Access Compliance Report

Public Rights-of-Way

(Curb Ramps)

Intersection ID: 14505	Main Street: REMOUNT_RD	Cross Street: REMUS_RD	Location:	N
ADA ID: 6C5661332FAD	Ramp Type: PerpDiag	Initial Pass/Fail: Fail	Overall Compliance: No	Severity Score: 72.5
Codes/Mitigation Info/Possible Solution		Field Measurements/Component Compliance

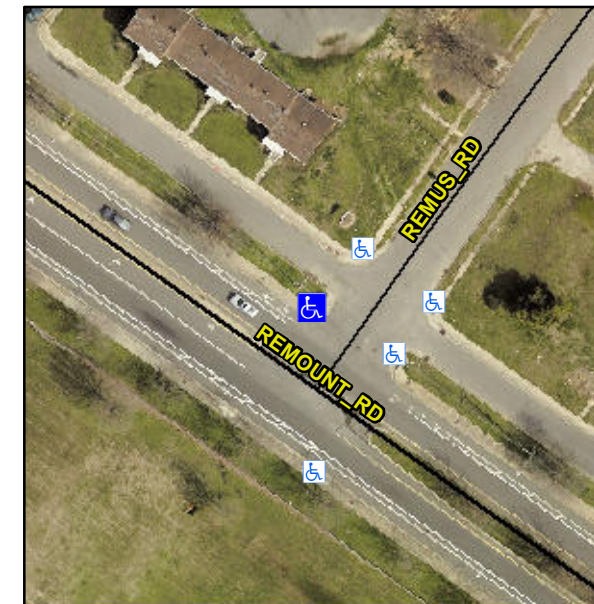
Not Found, R304.5.1, R304.2.2, R304.5.3

Compliance	Description	Data	Compliance	Description	Data
N/A	Ramp Length (in)	56.0	No	Ramp Slope (%)	8.9
No	Ramp Width (in)	29.0	No	Ramp XSlope (%)	10.5
N/A	Flare Type LT	N/A	N/A	Flare Type RT	N/A
N/A	Flare Slope LT (%)	N/A	N/A	Flare Slope RT (%)	N/A
N/A	Flare Traversable LT?	N/A	N/A	Flare Traversable RT?	N/A
N/A	Landing Length (in)	N/A	N/A	DWS Provided?	N/A
N/A	Landing Width (in)	N/A	N/A	DWS Contrast?	N/A
N/A	Landing Slope (%)	N/A	N/A	DWS Length (in)	N/A
N/A	Landing X Slope (%)	N/A	N/A	DWS Full Width?	N/A
N/A	Landing Curb? (Y/N)	N/A	N/A	DWS Offset (in)	N/A
N/A	Shared Landing?	N/A			
N/A	Gutter Ponding?	N/A	N/A	Gutter Slope (%)	N/A
N/A	Gutter Lip Ht (in)	N/A	N/A	Gutter X Slope (%)	N/A
N/A	Painted X Walk1?	No	N/A	Painted X Walk2?	No
	X Walk 1 Direction	To SW		X Walk 2 Direction	To SE
N/A	X Walk 1 Width (in)	N/A	N/A	X Walk 2 Width (in)	N/A
	X Walk 1 Slope (%)	1.6		X Walk 2 Slope (%)	3.9
	X Walk 1 X Slope (%)	0.1		X Walk 2 X Slope (%)	5.4

Remove & Replace Curb Ramp With Two New Directional Ramps or Equivalent.
